MONTGOMERY COUNTY PLANNING DEPARTMENT
THE MARYLAND-NATIONAL CAPITAL PARK AND PLANNING COMMISSION

MEMORANDUM

REVIEW TYPE: Preliminary Plan of Subdivision

PROJECT NAME: 4823 Rugby Avenue
CASE #: 120070760
REVIEW BASIS: Chapter 50, Montgomery County Subdivision Regulations

Figure 3: Preliminary Plan

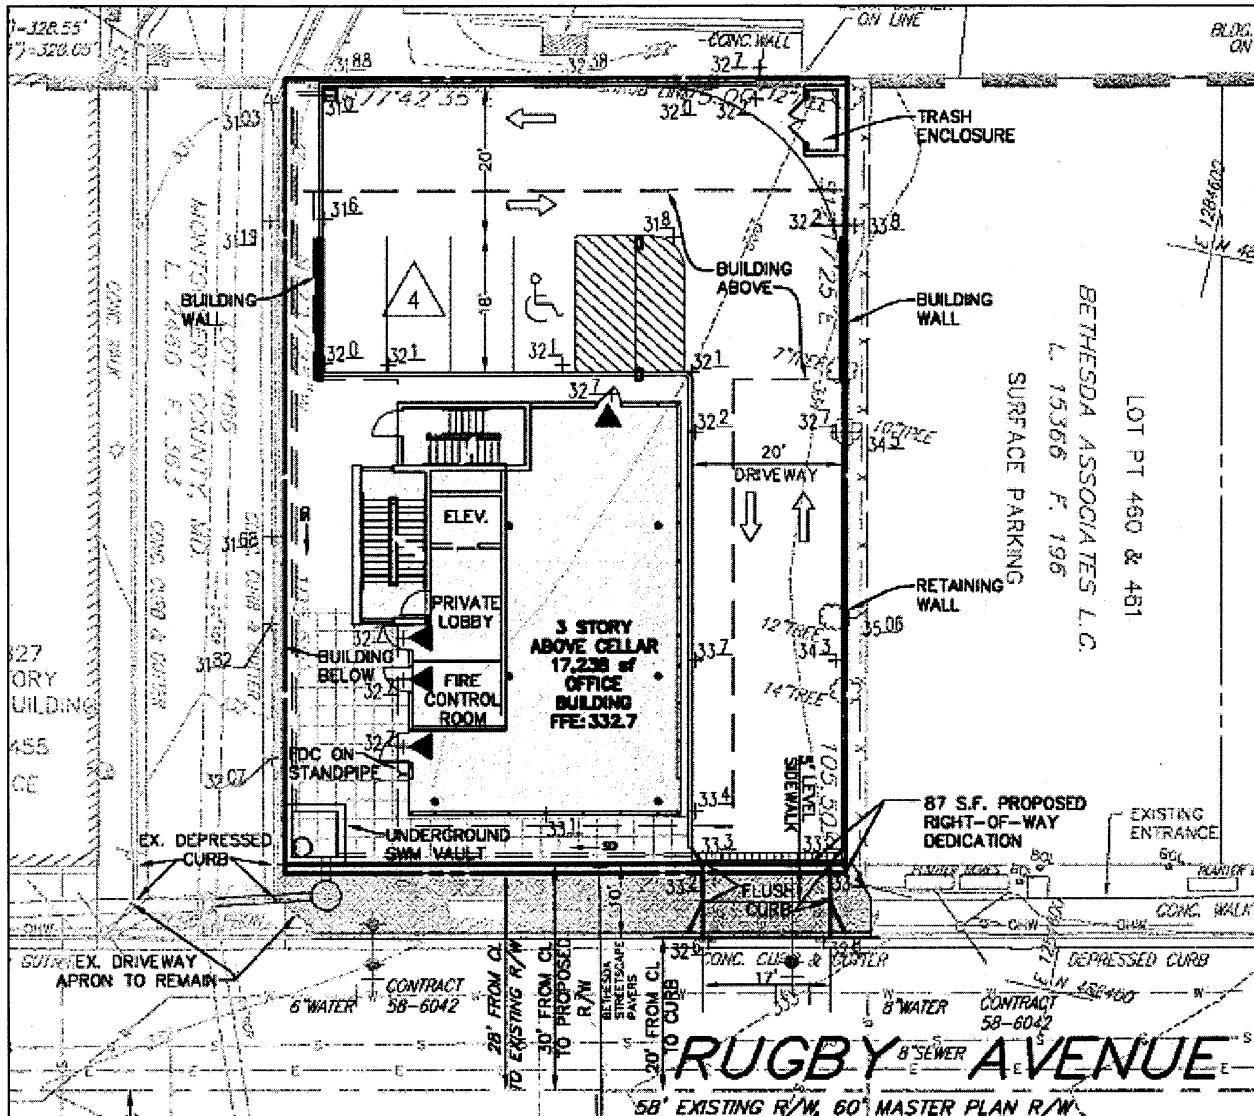
We have completed our review of the amended preliminary plan that was signed and submitted to our office on January 11, 2010. An earlier version of the revised preliminary plan for this site was reviewed by the Development Review Committee at its meeting on November 16, 2009. We recommend approval of the plan subject to the following comments:

1. Previous comments in our June 30, 2008 letter for the earlier Preliminary Plan for this site (no. 120070760) remain applicable unless modified below. **This letter supercedes our January 15, 2010 letter for this project; please disregard that letter.**
2. The sight distances study has been accepted. A copy of the accepted Sight Distances Evaluation certification form is enclosed for your information and reference.
3. We have approved the applicant's request for a design exception from our driveway spacing policy for commercial and multi-family residential driveway entrances. We also support approval of the recently amended driveway entrance design on Rugby Avenue.

4. Record plat to reflect denial of vehicular access along driveway for Montgomery County Parking garage abutting this site.

Applicant to provide clearance for and construct a pedestrian path from Rugby Avenue, along the western edge of the property, to access the County Garage at the rear of the site. The leadwalk will be located partially on County (Parking Lot District) and applicant's properties. The leadwalk is to be five (5) foot wide (typical), transitioning back to tie into the existing sidewalk (approximately four feet wide) prior to the County's garage property.

5. An off-street truck loading space is not required for this project, based on the proposed Gross Floor Area in the "Development Information" table on the plan.

8. Since the runoff from the site will be reduced as a result of this redevelopment, we accept the storm drain capacity analysis. No public drainage improvements will be required of this applicant.
